Attachment B

Selected Drawings

New The Salvation Army Accommodation & Mixed Use Development

PROJECT
Foster House
5-19 Mary St, Surry Hills NSW 2010

1 Hands Lane - Elevation
Scale: 1:200

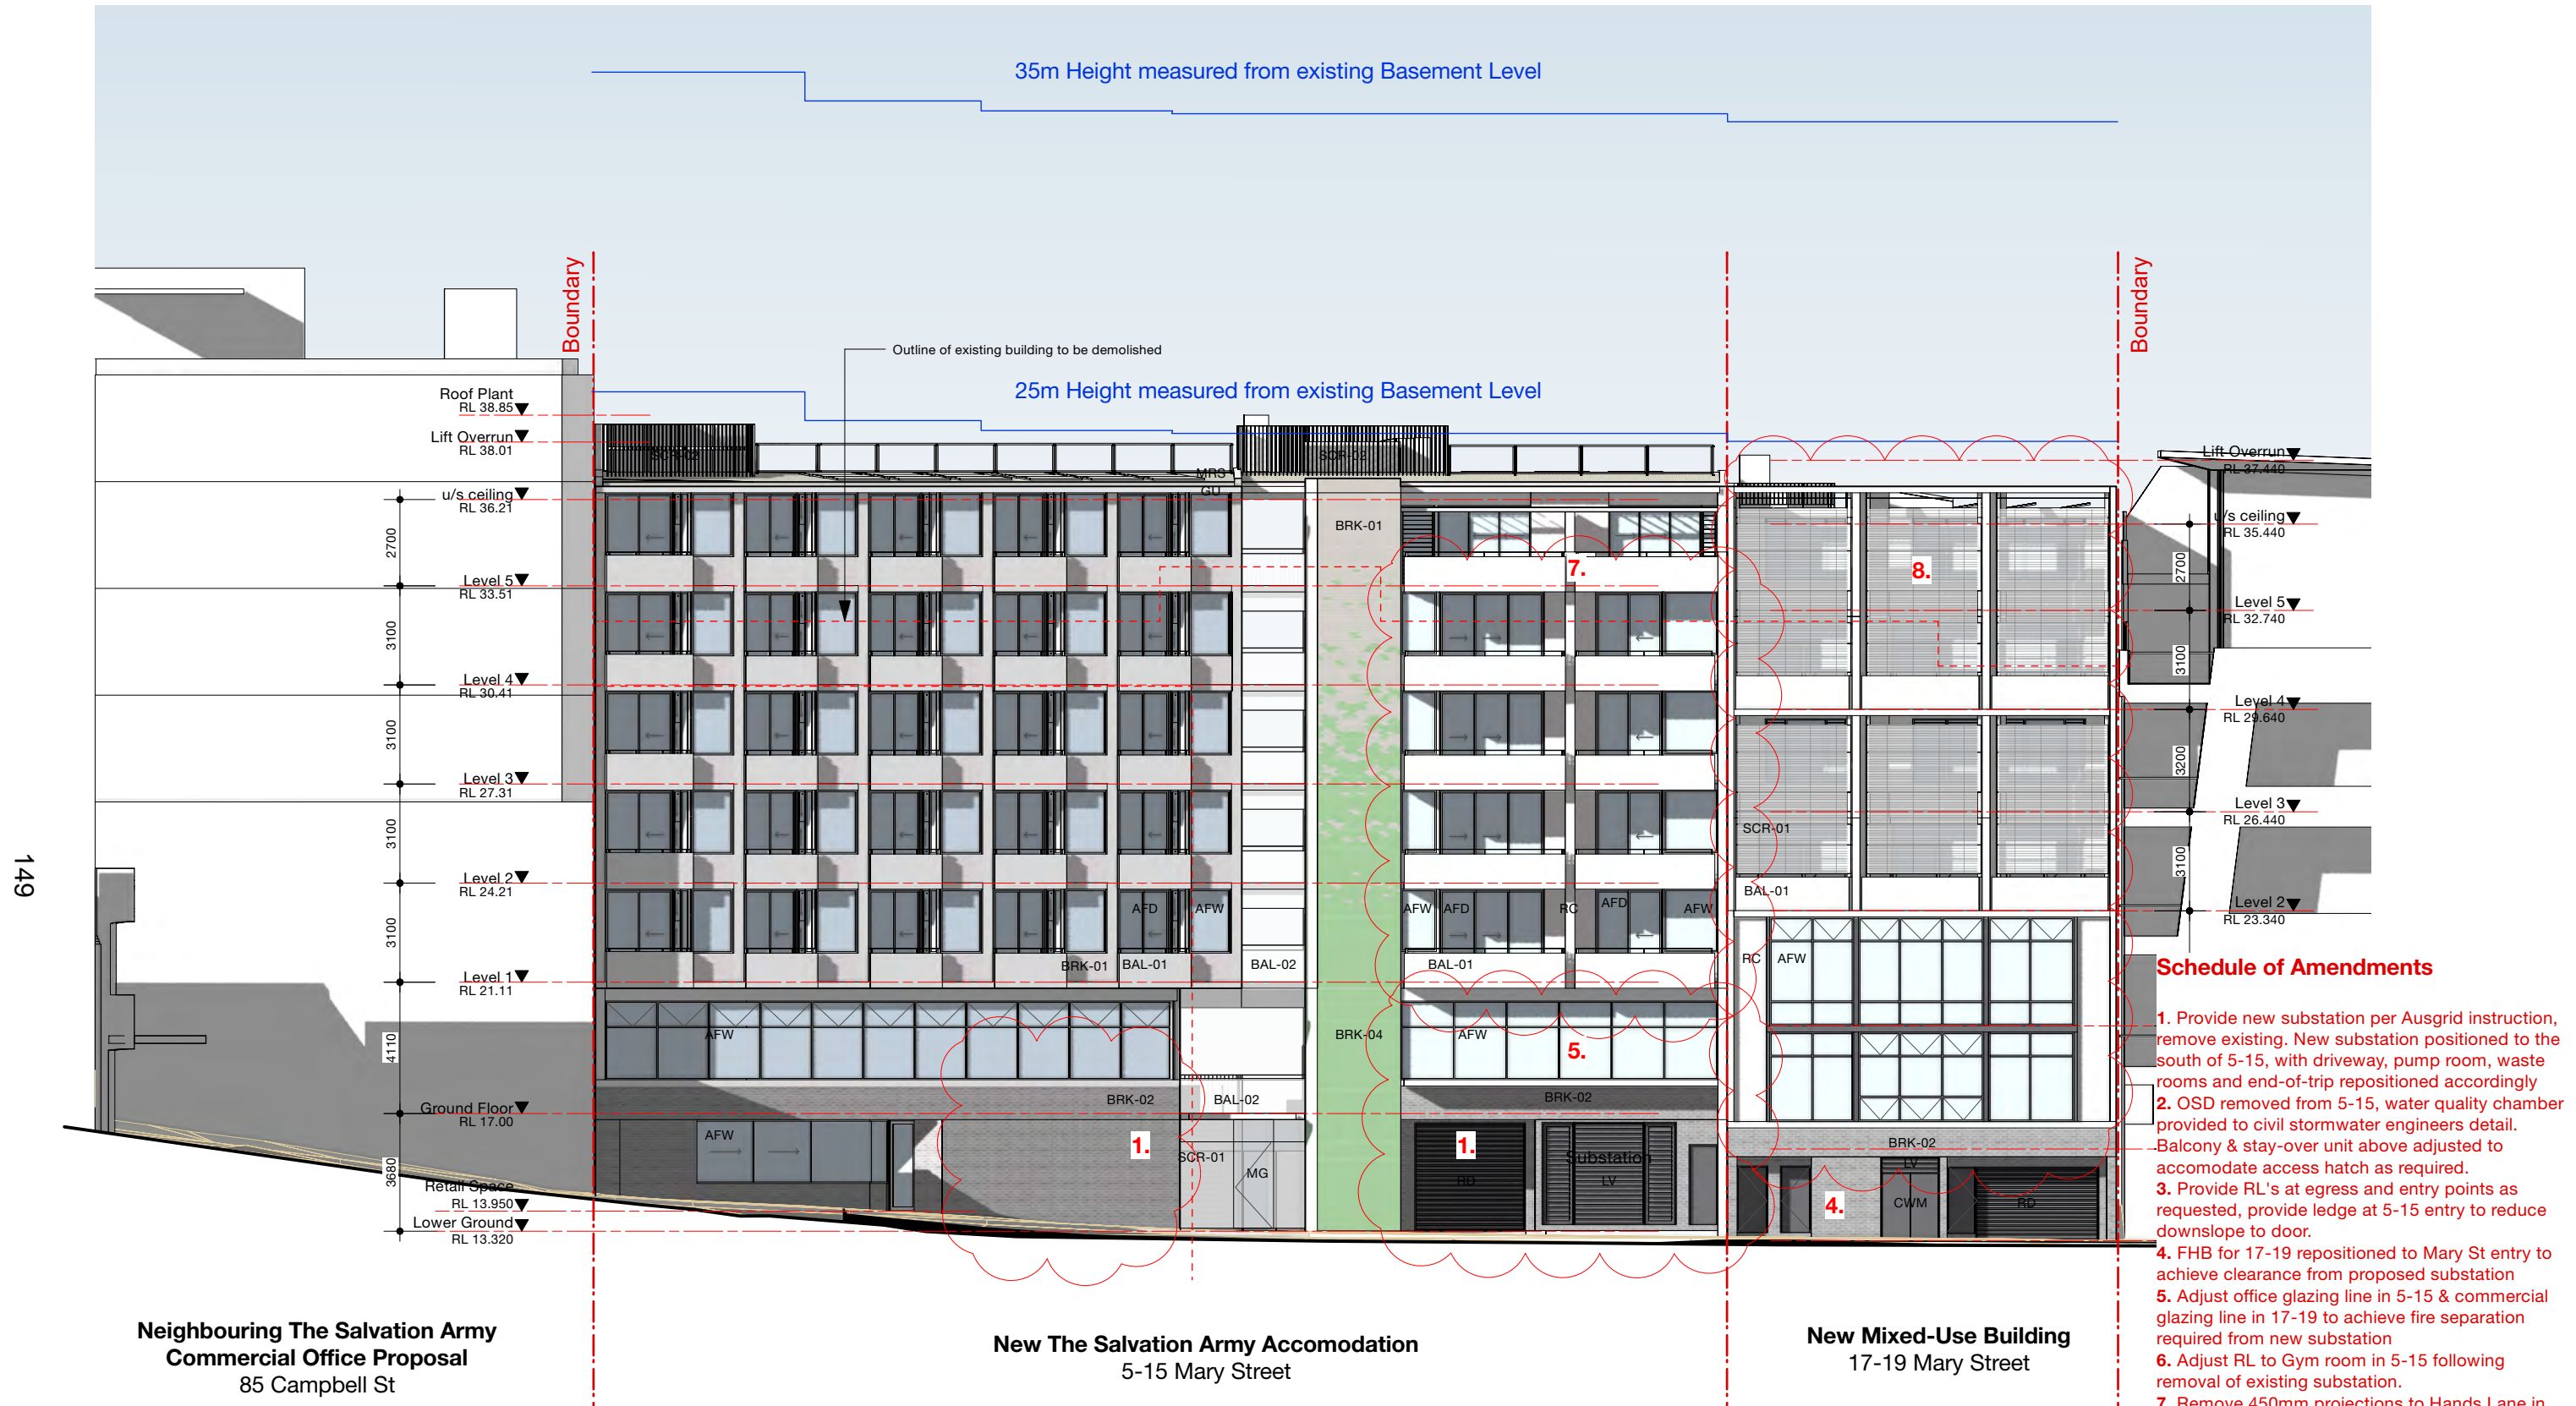
- Schedule of Amendments**
1. Provide new substation per Ausgrid instruction, remove existing. New substation positioned to the south of 5-15, with driveway, pump room, waste rooms and end-of-trip repositioned accordingly

2. OSD removed from 5-15, water quality chamber provided to civil stormwater engineers detail.
 3. Balcony & stay-over unit above adjusted to accommodate access hatch as required.

4. Provide RL's at egress and entry points as requested, provide ledge at 5-15 entry to reduce downslope to door.
 5. FHB for 17-19 repositioned to Mary St entry to achieve clearance from proposed substation

6. Adjust office glazing line in 5-15 & commercial glazing line in 17-19 to achieve fire separation required from new substation
 7. Adjust RL to Gym room in 5-15 following removal of existing substation.

8. Remove 450mm projections to Hands Lane in 5-15 for units south of the lift core, adjusting unit plan accordingly
 9. Remove 450mm projection to Hands Lane in 17-19, adjusting plans accordingly

9. Remove projection to Mary St for balcony of unit 112, adjust unit plan accordingly

DRAWING TITLE			
Section A - East West 17-19			
JOB NO	DRAWN	SCALE	DRAWING NO.
22.19	AR/JK	1:200	2.301
DATE	CHECKED	PLOT DATE	REVISION
23/5/22	PT		D

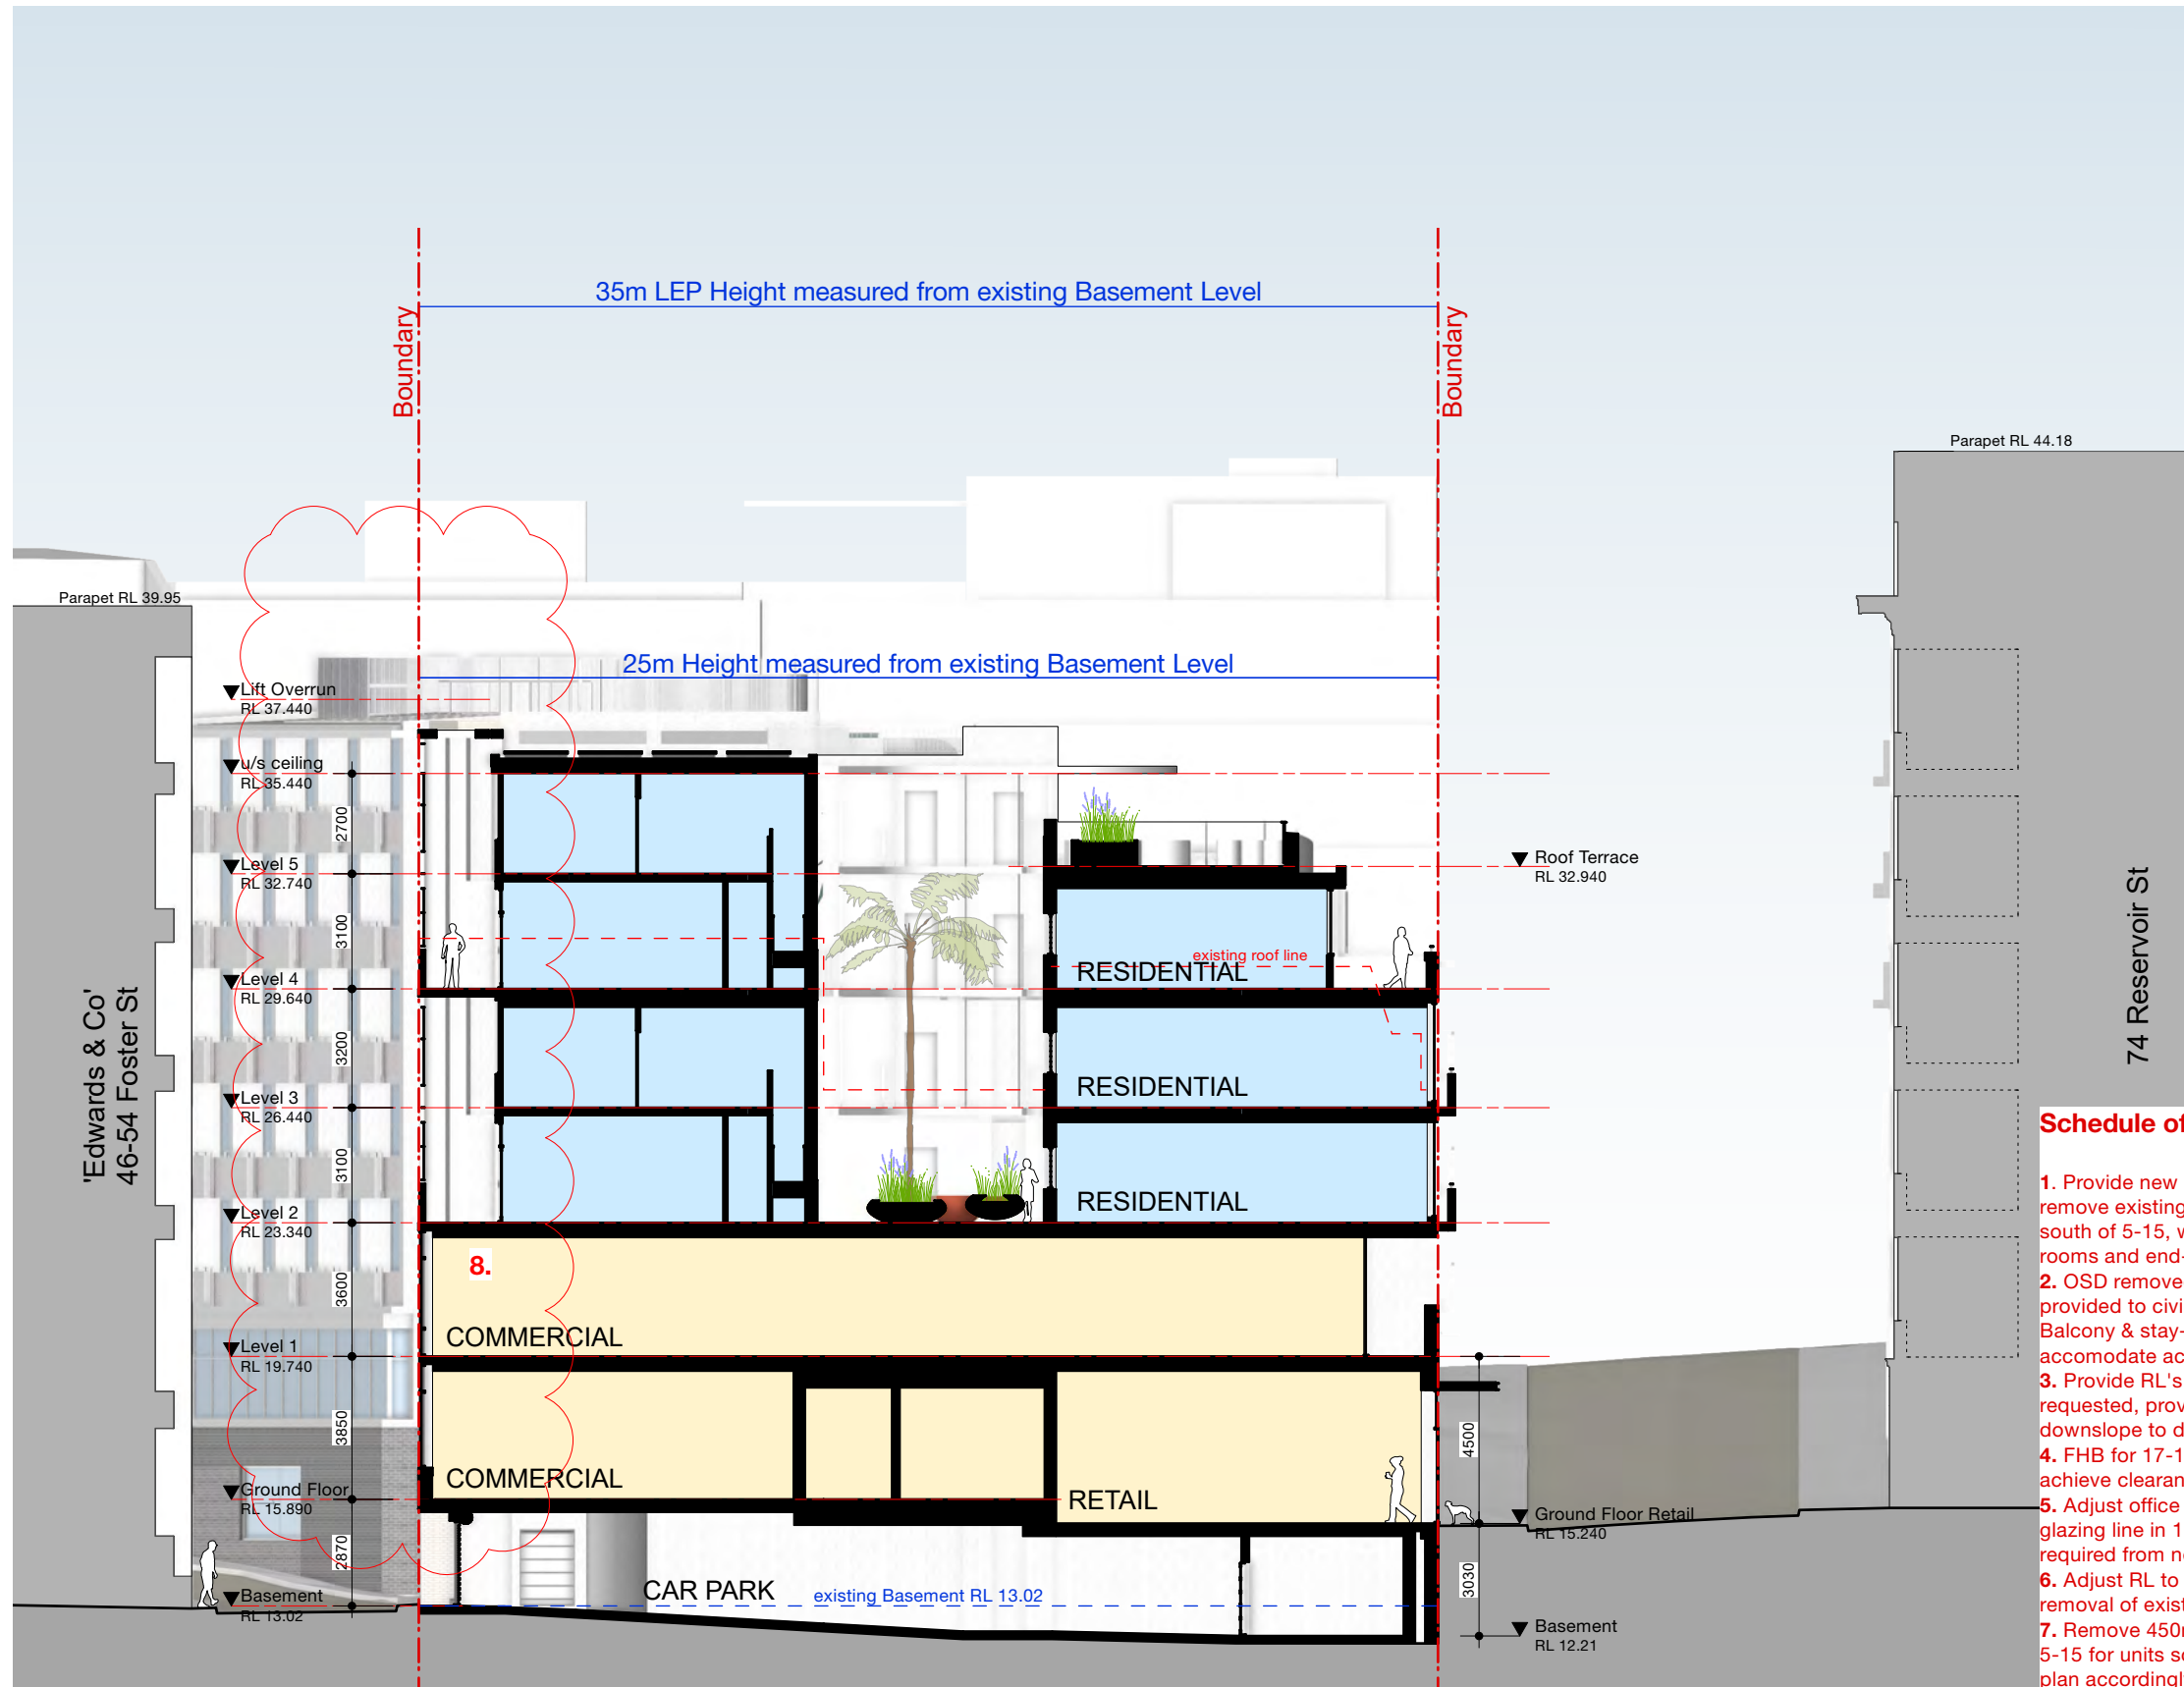
1. Provide new substation per Ausgrid instruction, remove existing. New substation positioned to the south of 5-15, with driveway, pump room, waste rooms and end-of-trip repositioned accordingly

2. OSD removed from 5-15, water quality chamber provided to civil stormwater engineers detail. Balcony & stay-over unit above adjusted to accommodate access hatch as required.

3. Provide RL's at egress and entry points as requested, provide ledge at 5-15 entry to reduce downslope to door.
4. FHB for 17-19 repositioned to Mary St entry to achieve clearance from proposed substation

7. Remove 450mm projections to Hands Lane in 5-15 for units south of the lift core, adjusting unit plan accordingly
8. Remove 450mm projection to Hands Lane in 17-19, adjusting plans accordingly

9. Remove projection to Mary St for balcony of unit 112, adjust unit plan accordingly
